AIRPORT LAND USE COMMISSION

**TUOLUMNE COUNTY
SPECIAL MEETING FOR
AIRPORT LAND USE COMMISSION
A.N. FRANCISCO BUILDING
48 YANEY AVENUE, 4TH FLOOR CONFERENCE ROOM
Thursday, June 13, 2024
5:00 p.m.**

1. **Met3 Wireless**, ALUC24-03 for the review of Conditional Use Permit LUNR-23-12 to allow the development a new 100 foot monopine cell tower inside a 50 foot by 50 foot fenced area with a 6 foot high chain-link fence on a 48.74± acre parcel zoned A-20 & O (General Agriculture, Twenty Acre Minimum & Open Space) under Title 17 of the Tuolumne County Ordinance Code (TCOC).

ALUC MAP

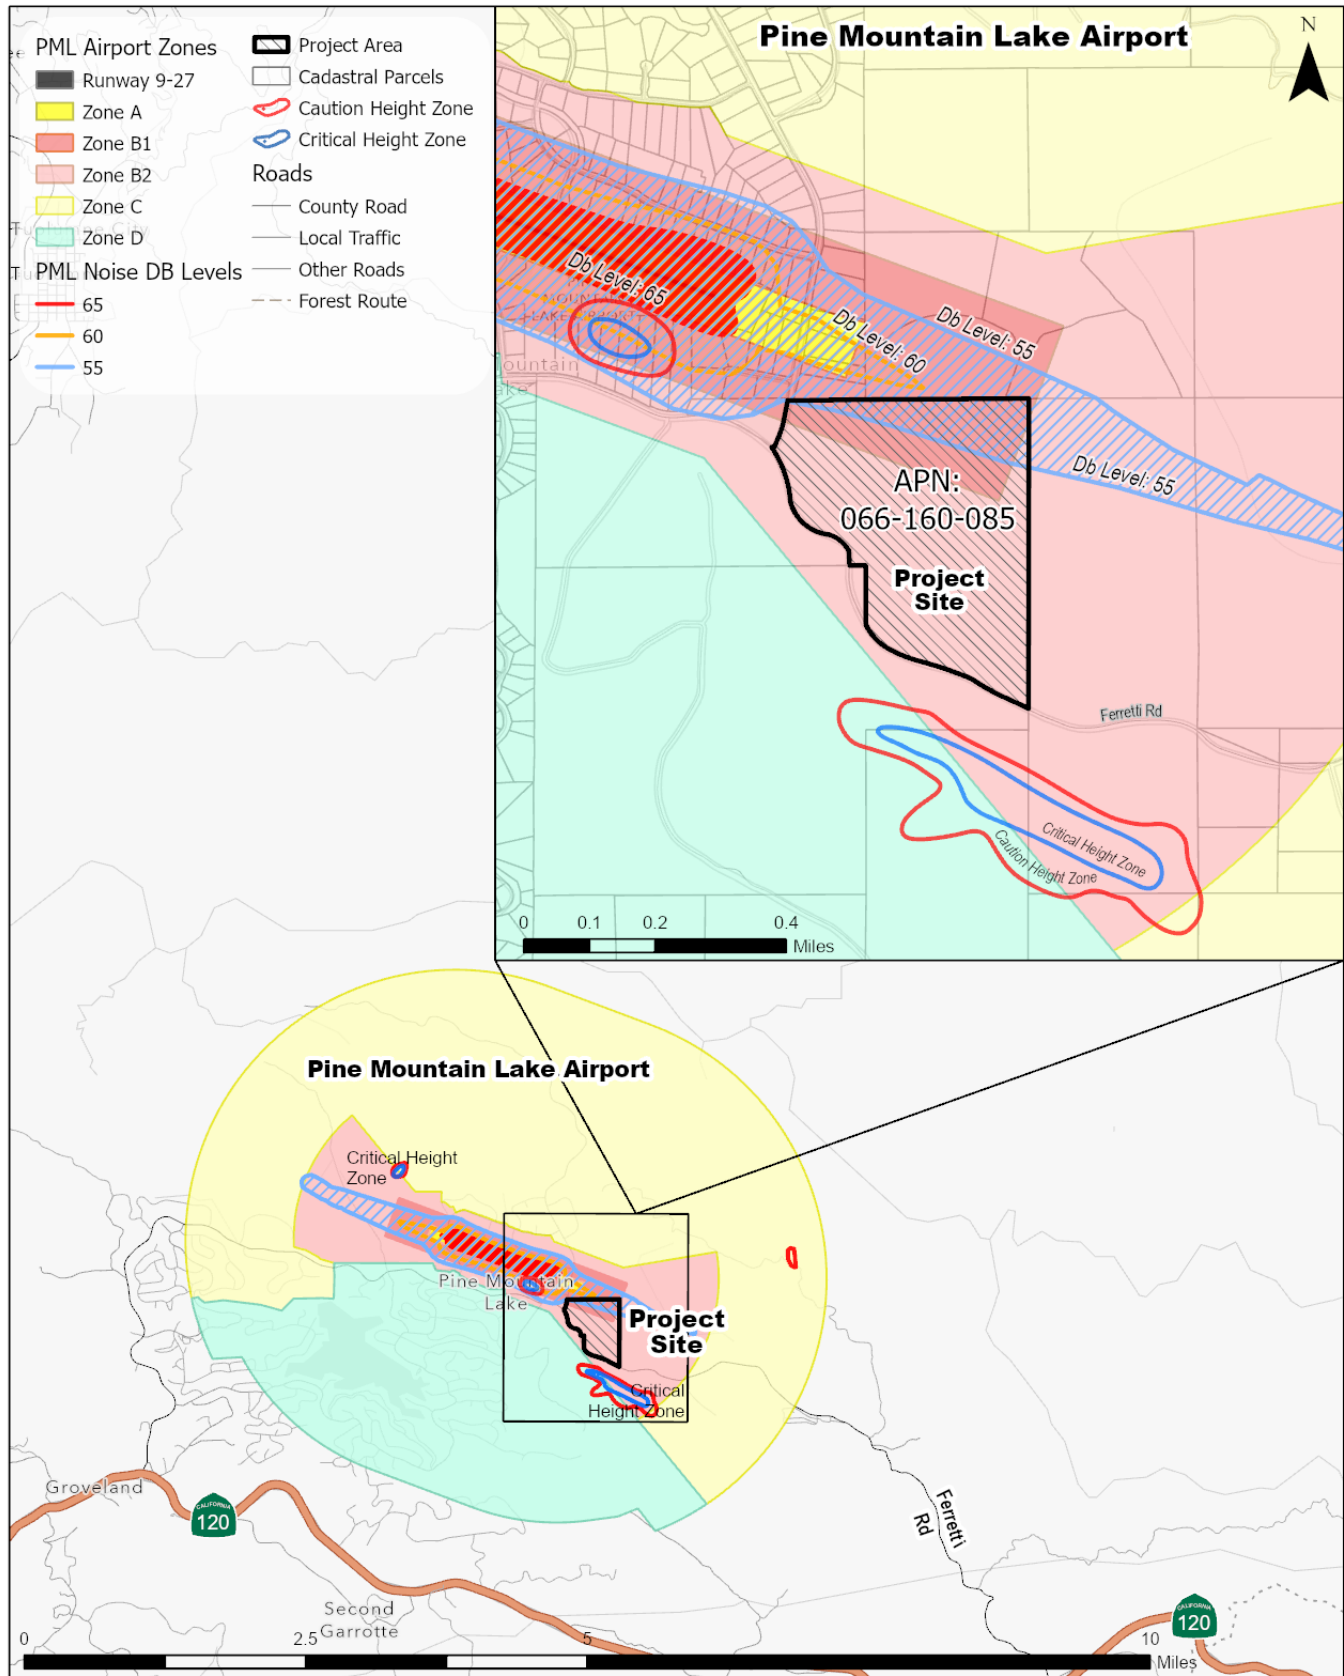
2. The revised tentative subdivision map is attached to this current report. The project is proposing 13 lots ranging from 5± to 10± acres. The residential density within Zone B1 allows 1 dwelling unit per 10-acre parcel. A variance is being requested by the applicant for proposed Parcel 5 (previously Parcel 1). The acreage proposed is approximately 5.77± acres, which does not meet the minimum acreage density of 10± acres required within Zone B1. When considering the request for a Variance or other special condition, the ALUC is directed to follow section 2.24.3(e) of the ALUC Compatibility Plan. A copy of this section has been attached to this report for the Commissions consideration.

4. The project site is located in Compatibility Zones B1 and B2 associated with the Pine Mountain Lake Airport. The project site is not located within a Height Restricted Zone or a Critical Height Zone. The ALUC is being requested to review the proposed project and determine if it is consistent with the provisions of compatibility zones B1 and B2, and consistent with the Airport Land Use Compatibility Plan. Additionally, the ALUC is being requested to consider a variance to allow proposed Parcel 5 of Tentative Subdivision Map TSM20-002 to be 5.77 acres in size, which is inconsistent with the density requirements within the B1 Compatibility Zone.

6. The 55 dB noise contour falls through the portion of the site within Zone B1, through Parcels 5, 6, and 13. Information of uses within these noise contours can be found in Table 2b of the Tuolumne County Airport Land Use Compatibility Plan, as shown below. A condition as indicated above was added by the Commission during the October 1, 2020 meeting to address noise.

7. The residential density within Zone B1 allows 1 dwelling unit per 10-acre parcel. Proposed Parcels 5, 6 and 13 would be located within Compatibility Zone B1. Parcel 5 would be 5.77± acres in size, Parcel 6 would be 10.07± acres in size, and Parcel 13 would be 10.04± acres in size. Any building permit within Zone B1 would be required to be referred to the ALUC, consistent with Policy 2.1.5.2(b)(1) of the Compatibility Plan.

- d. Any use which may attract large flocks of birds.
 3. All parcels located within or partially within Compatibility Zone B1 shall be a minimum of ten gross acres in size **with the exception of proposed parcel 5**, consistent with the density policies of the Airport Land Use Compatibility Plan. All parcels located within Compatibility Zone B2 shall be a minimum of three gross acres, consistent with the density policies of the Compatibility Plan. This shall be verified prior to the approval of the Final Map.

4. A deed restriction shall be recorded for each parcel to acknowledge the proximity of the Pine Mountain Lake Airport and the requirement to comply with the Tuolumne County Airport Land Use Compatibility Plan. The restrictions shall include information that parcels with higher elevations may have height limits imposed on future structures. This would trigger additional review by the ALUC.
